EASA	COMMENT RESPONSE DOCUMENT
	<p>EASA PAD No. 15-041</p> <p>[Published on 15 April 2015 and officially closed for comments on 29 April 2015]</p>

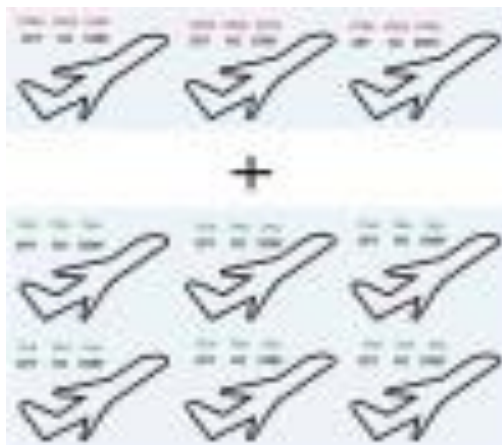
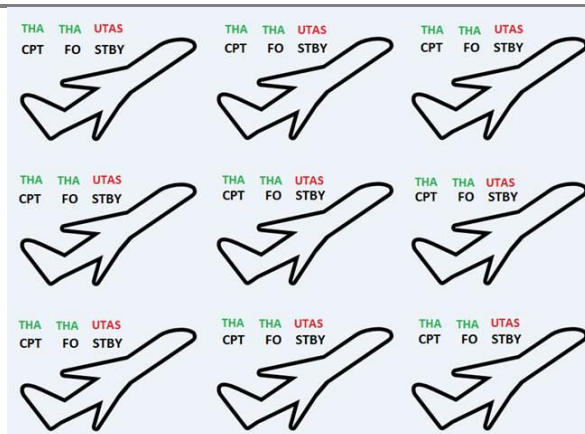
Vueling is concerned about those 3 a/c with 3 AoA UTAS, MSN 5877, 5940, 5885, and Vueling would like to improve the situation as soon as possible (from a Safety point of view). If Vueling waits for the 6 THALES AoA's P/N C16291AB to be supplied in according with Airbus RIL SA34M15001474 and install them to comply with the future AD, Vueling could have the 3 UTAS aircraft flying with this configuration for 21 months. To reduce as much as possible the number of Vueling flights operated with the fully AoA UTAS configuration, and to comply with PAD/future AD as soon as possible, Vueling proposes the following:

- Uninstall the 6 UTAS sensors at the Captain and First Officer positions of the 3 fully UTAS a/c's MSN 5877, 5940, 5885.
- Uninstall the 6 Thales sensors at the Standby position of a/c's fully Thales (-AB) and with ELAC L97+ MSN 6450, 6483, 6510, 6518, 6535, 6557.
- Install the removed 6 UTAS sensors at the Standby position of a/c's fully Thales (-AB) and with ELAC L97+ MSN 6450, 6483, 6510, 6518, 6535, 6557.
- Install the removed 6 Thales sensors at the Captain and First Officer positions of the 3 fully UTAS a/c's MSN 5877, 5940, 5885
- The result is: 9 aircrafts with the intermix AoA sensors configuration 2 Thales – 1 UTAS (the same configuration that results from the application of SB A320-34-1610 / PAD 15-041 / future AD). Graphically, the proposed modification can be explained as follows:

However, this action is not permitted by PAD 15-037 paragraph 17:

(17) For an aeroplane on which Thales P/N C16291AA and Thales P/N C16291AB AOA sensors are installed, from the effective date of this AD, or after modification of the aeroplane as required by paragraph (11) of this AD, as applicable, do not install any AOA sensor with a P/N as listed in [Table 2] of this AD on that aeroplane.

Could EASA analyse the alternative solution proposed by Vueling and check if the PAD 15-037 could be amended in order to allow it?

Comment understood, but not agreed. There is no Airbus published document to replace standby Thales probes with UTAS probes, but on a case-by-case basis, Airbus may provide approved instructions to allow such replacement, strictly as a temporary solution.

No changes have been made to the Final AD in response to this comment.
